Comments on the Pantex Plant Radiological Investigation Report

Prepared for Serious Texans Against Nuclear Dumping
revised June 9, 2004

The following are the comments prepared by the Institute for Energy and Environmental Research on the January 2004 *Pantex Plant Radiological Investigation Report*, henceforth referred to as the RI report. We have prepared this analysis for Serious Texans Against Nuclear Dumping (STAND) pursuant to a Technical Assistance Grant made to STAND by the U.S. Environmental Protection Agency.

Groundwater Data from Ogallala Aquifer

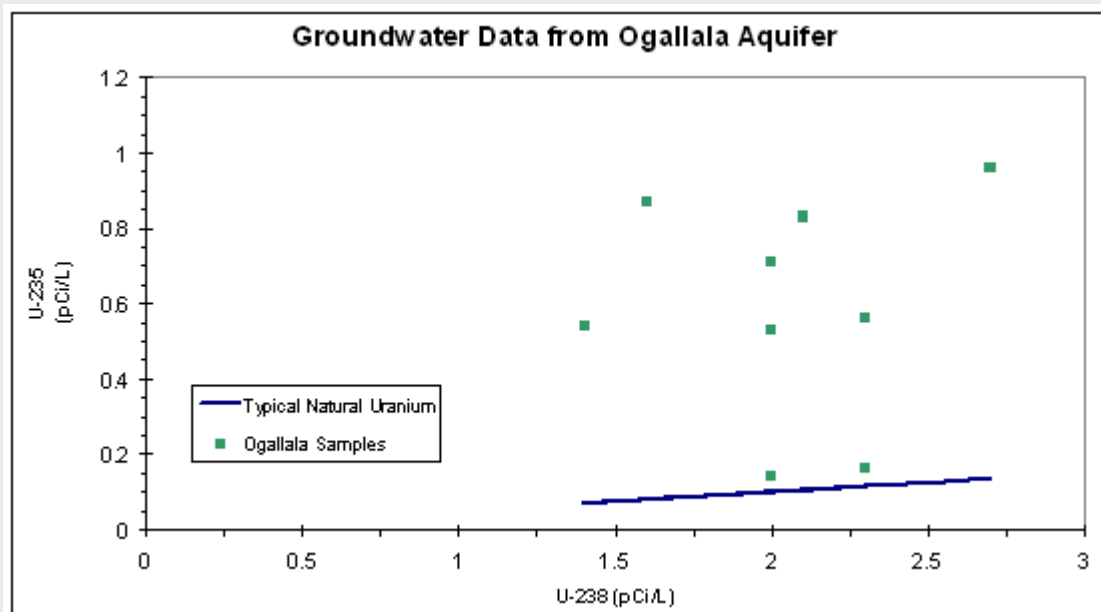
U-235 to U-238 activity is completely outside the range of expected value of about 0.05 for natural uranium (table C-10, p. C-88 and C-89). The RI report has offered no explanation for this problem. Below is a plot of the activity ratios for the 9 locations listed in the data tables as having a U-235 detection.

The solid line represents the expected ratios for natural uranium. Like for the soil samples, the ratios are too large and do not appear to show any obvious correlation. The activity ratios for the isotopes vary from 0.07 to 0.54, with an average of 0.3. This average ratio is 6 times that expected for typical natural uranium.
